Metro | Agenda

Meeting: SW Corridor Plan Steering Committee
Date: June 9, 2014
Time: 9:00 to 11:00 a.m.
Place: Metro Regional Center, Council Chambers
Purpose: Review and discuss recommendation for High Capacity Transit (HCT) options, multimodal projects and station areas for further study; update on Southwest Service Enhancement Plan and next steps.

Date: June 2, 2014
To: Southwest Corridor Steering Committee
From: Malu Wilkinson, Metro Southwest Corridor Project Manager
Matt Bihn, Metro Principal Transportation Planner
Subject: Summary of input and potential changes to the draft recommendation for Southwest Corridor HCT alignment options to study further

Discussion Draft Recommendations on HCT Options, Multimodal Projects, and Potential Station Areas for Further Study

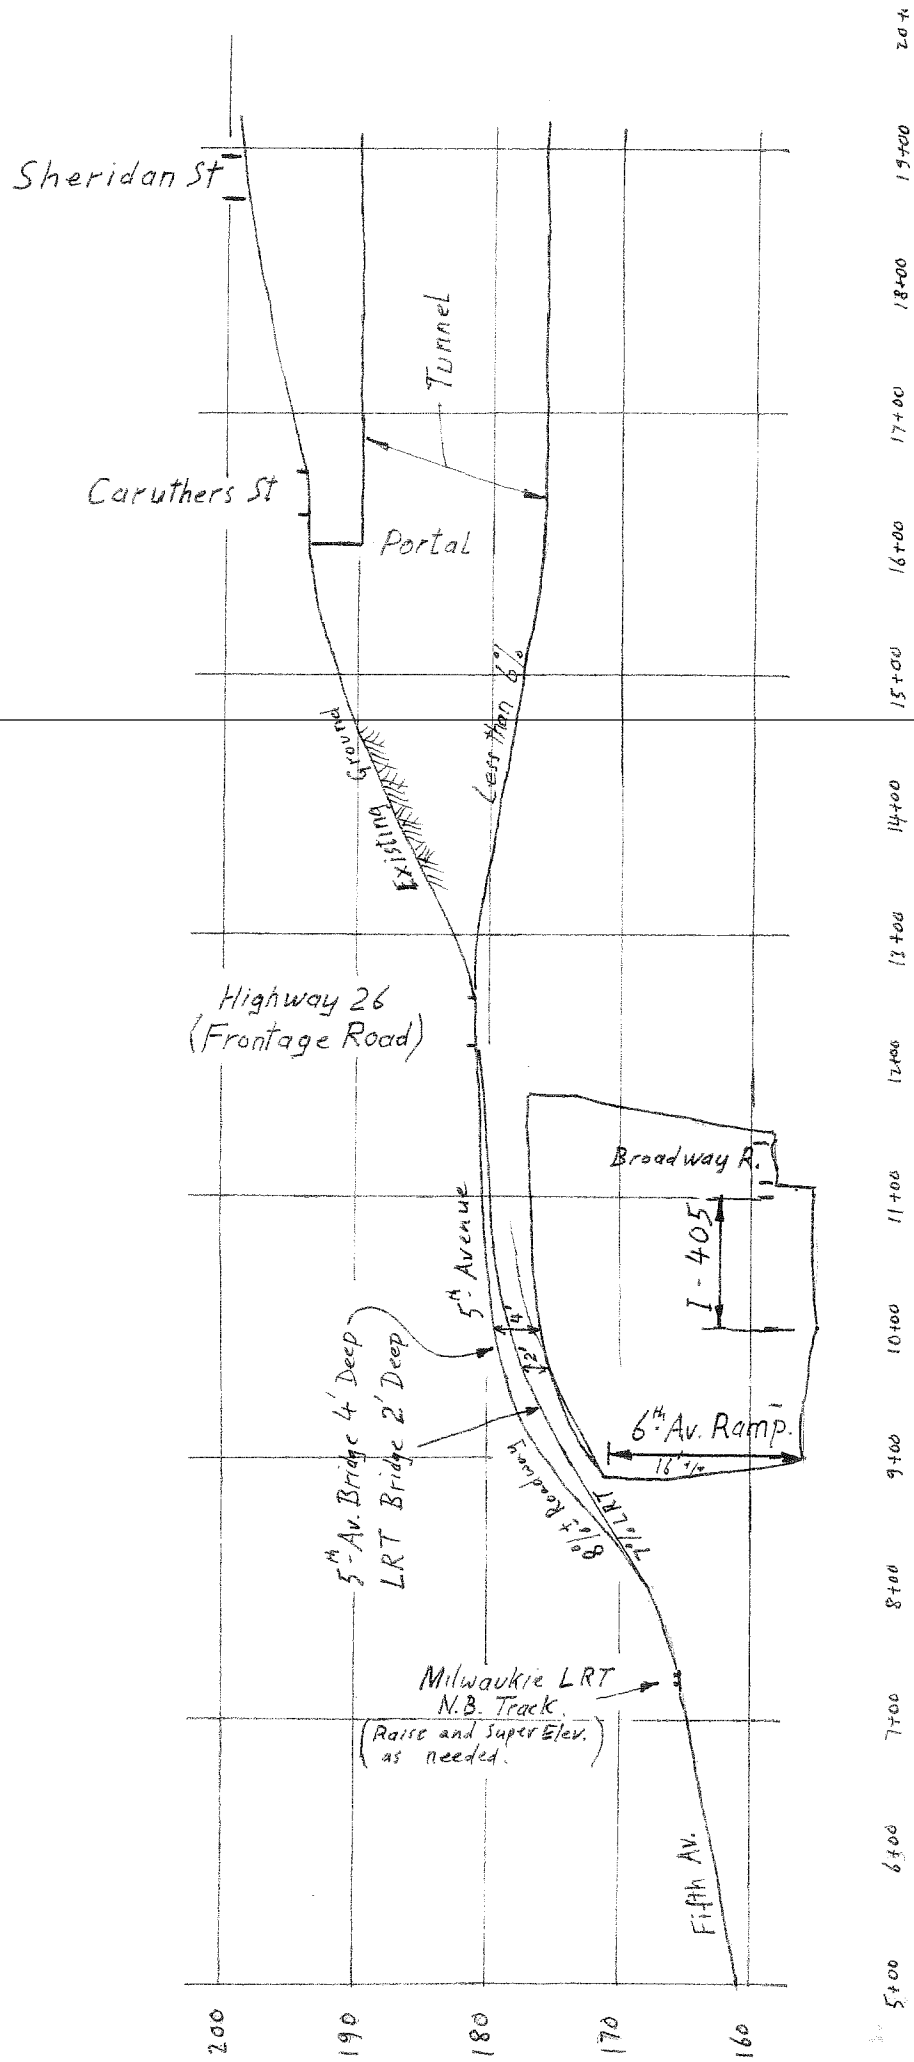
Serving PCC is important. One option might be to use some segments of streetcar type ROW along Capital Highway, which is seldom congested. PCC has not only the campus, but also **redevelopment potential** if parking needs can be reduced. It is also the station that would serve **Mountain Park and beyond**.

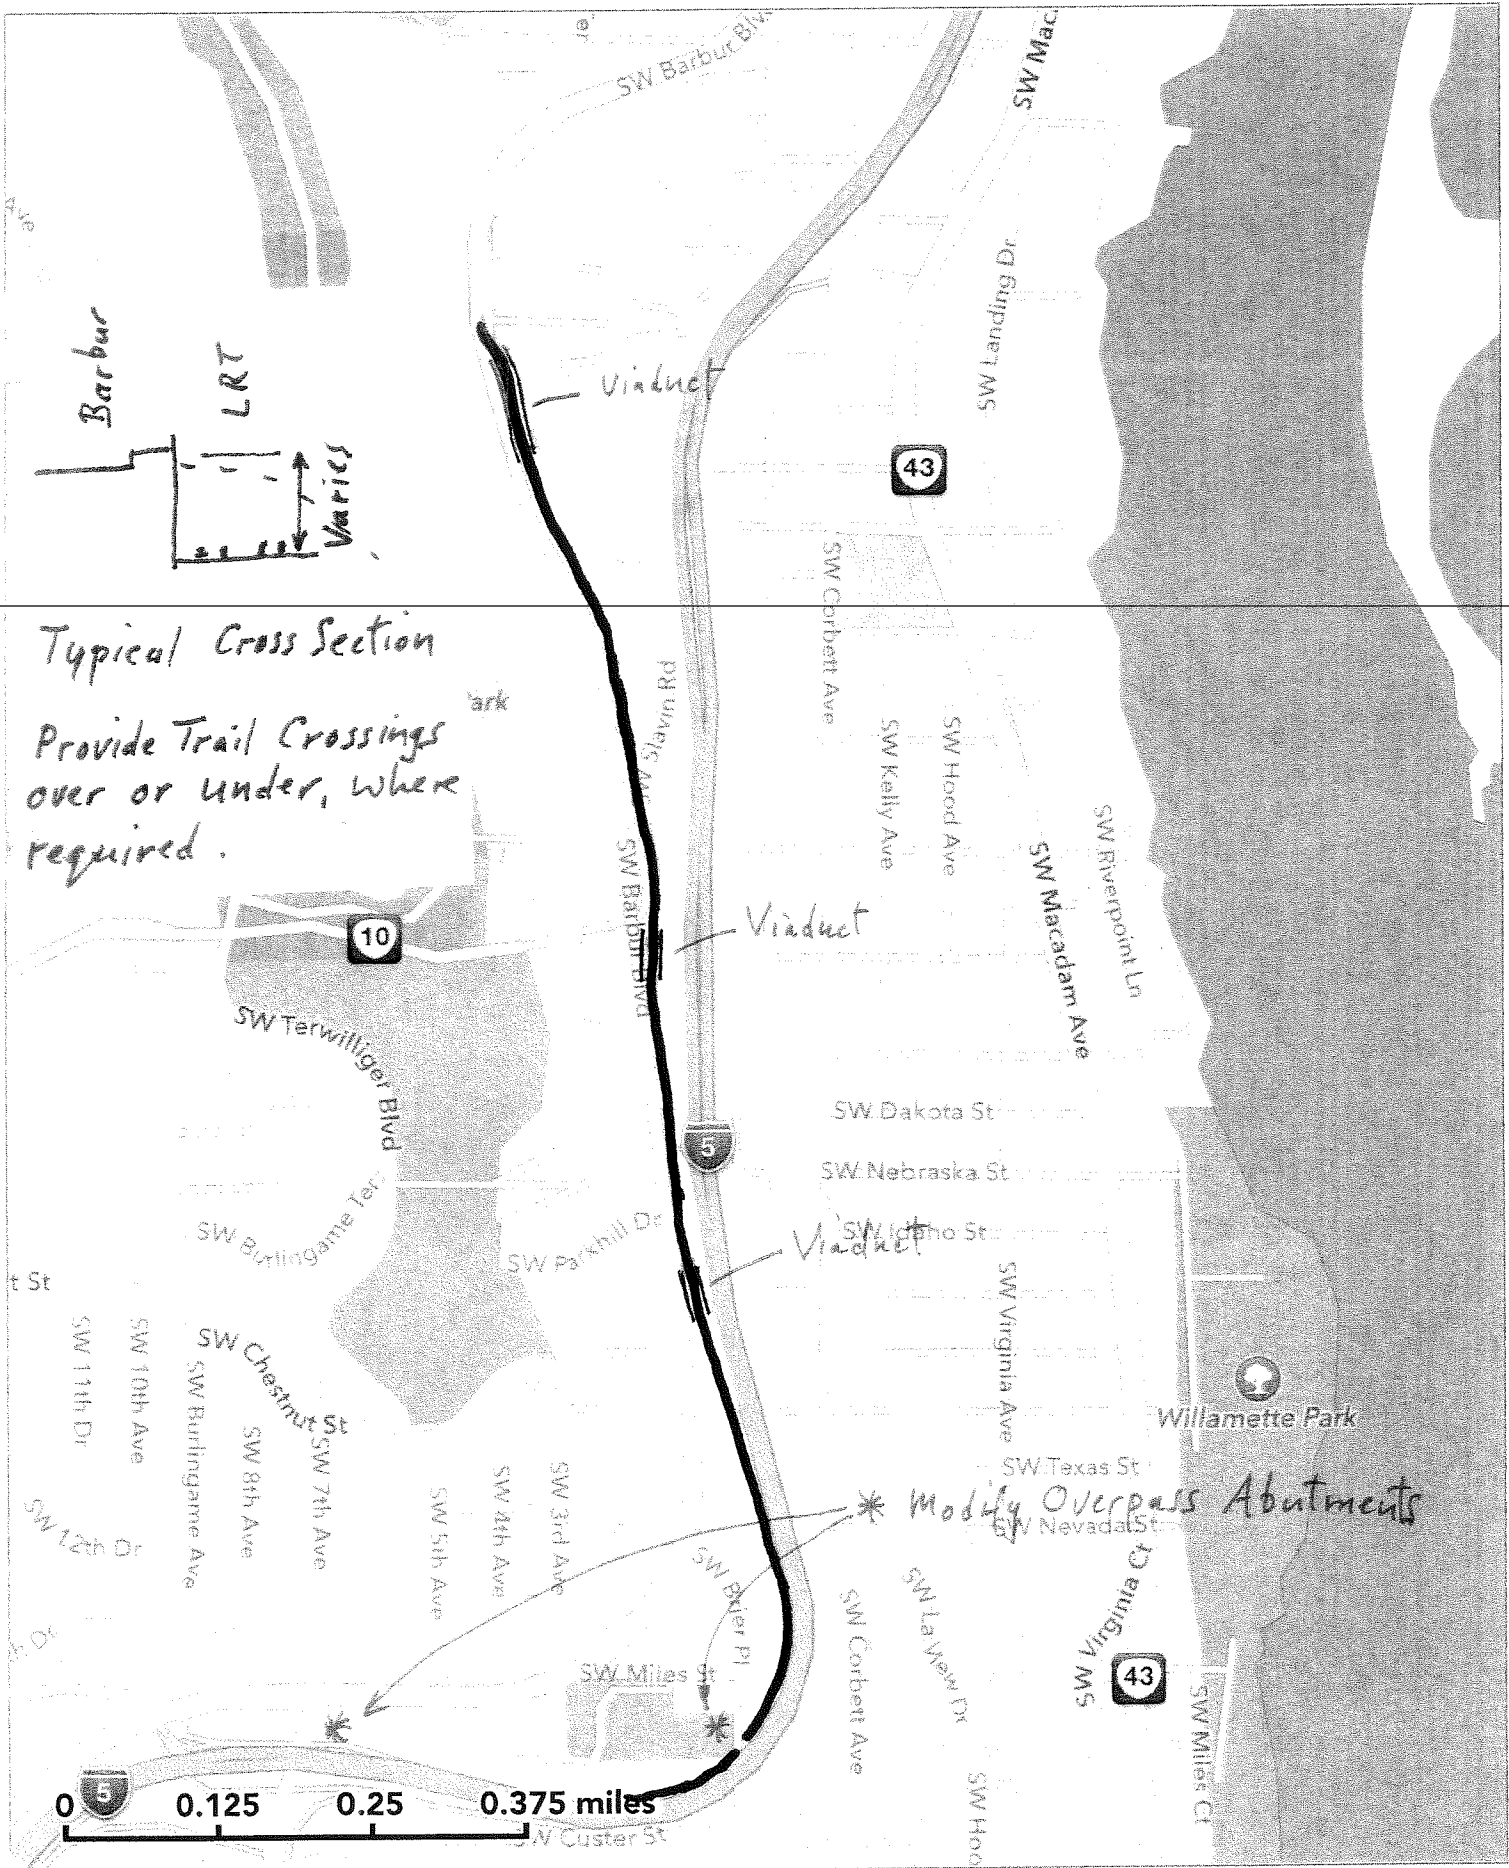
As mentioned, the HCT project offers the opportunity for a local traffic to **bypass the 217 Interchange**, connecting the Tigard Triangle to downtown Tigard.

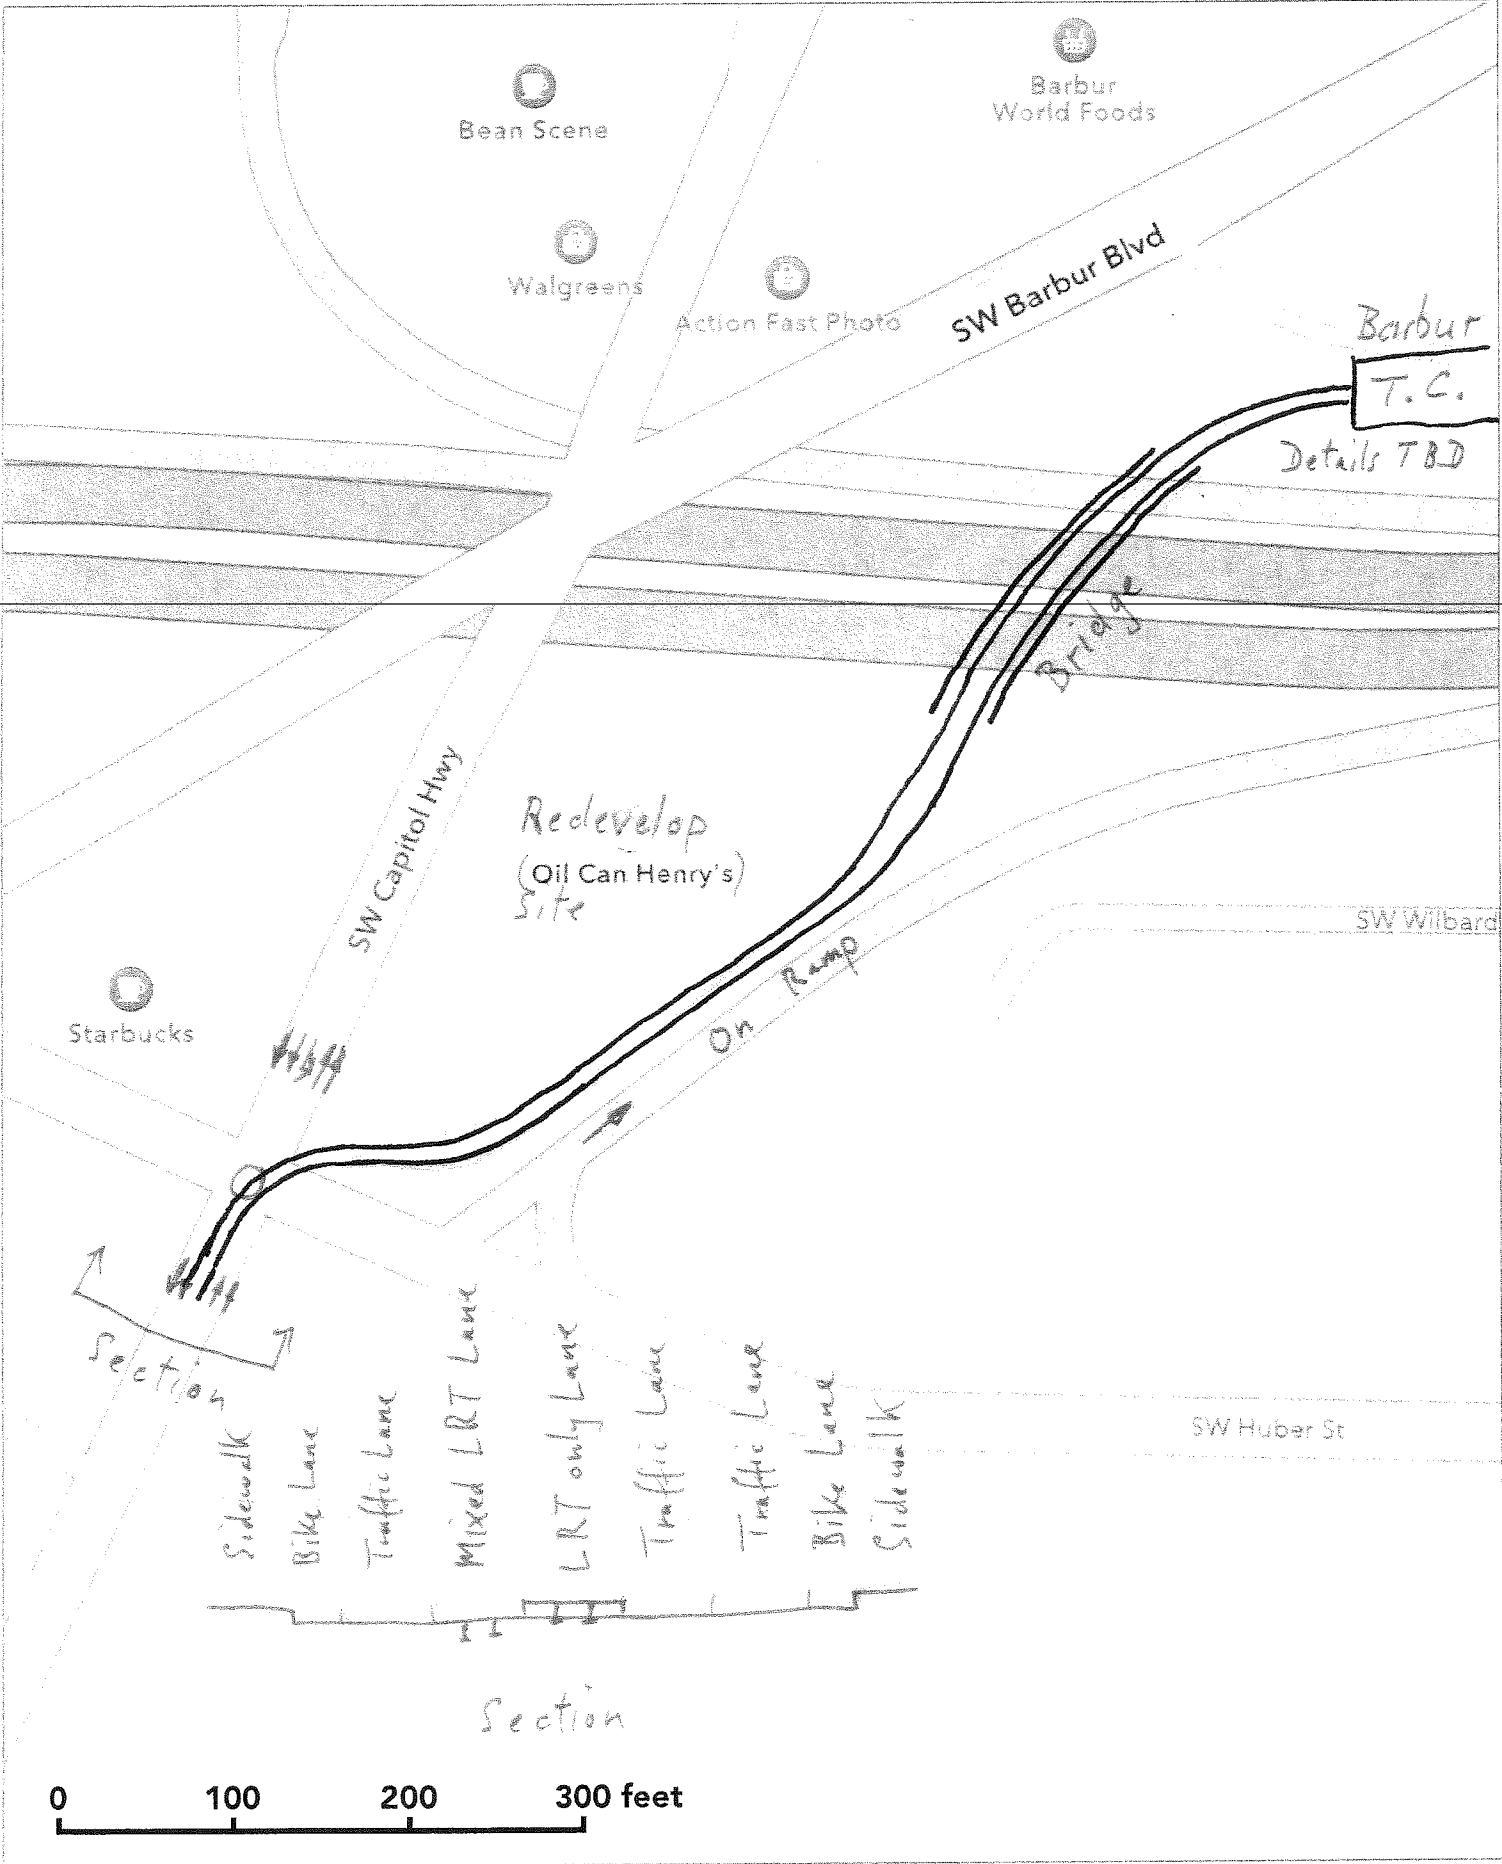
Finally, there doesn't seem to be a good entry alignment into central Tualatin. I don't think the south entry option, following I-5 to the Sherwood Highway Interchange was adequately considered, and further study seems to have been prematurely discarded.
